## **REMARKS**

## **DRAWINGS**

Figure - 2

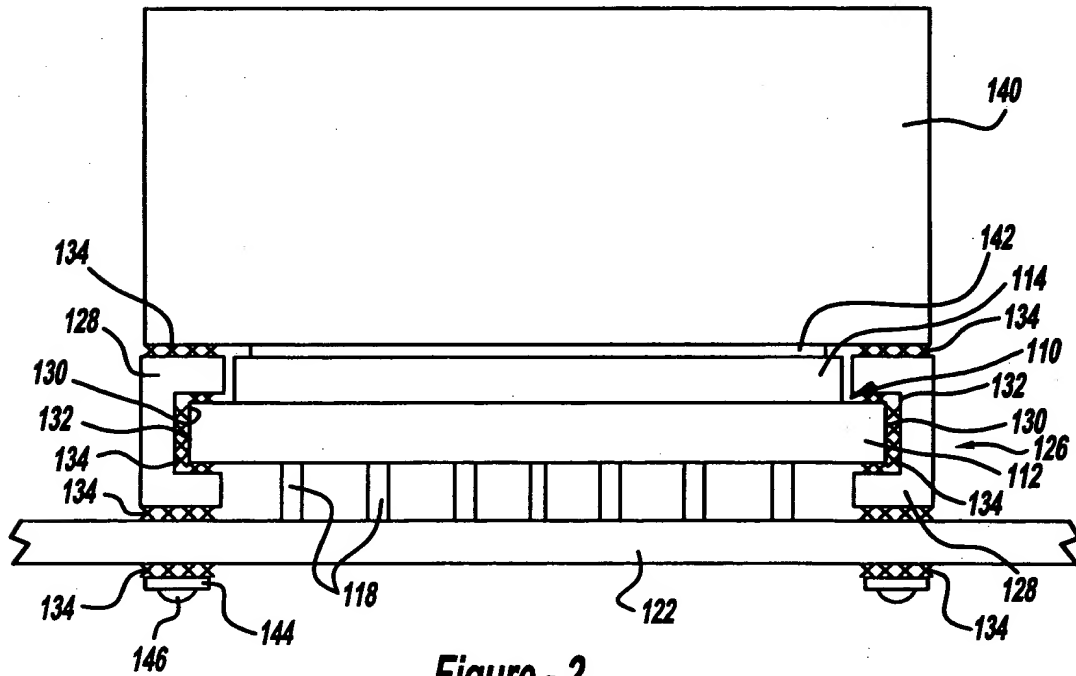
The drawings stand objected to as failing to comply with 37 CFR 1.84(p)(4) because reference characters "114" and "110" have both been used to designate for a package lid and the integrated package and characters "212" and "214" have both been used to designate for a package lid. This rejection has been accommodated.

The attached sheets of drawings include changes to Figures 2 and 3. With regard to Figure 2, the lead line and arrow point for reference numeral 110 has been modified to better indicate that it refers to the integrated circuit package and not just to the package lid 114. With regard to Figure 3, the lead line for reference numeral 212 has been extended to properly refer to the substrate. The attached sheets, which includes Figures 2 and 3, replace the original drawing sheets.
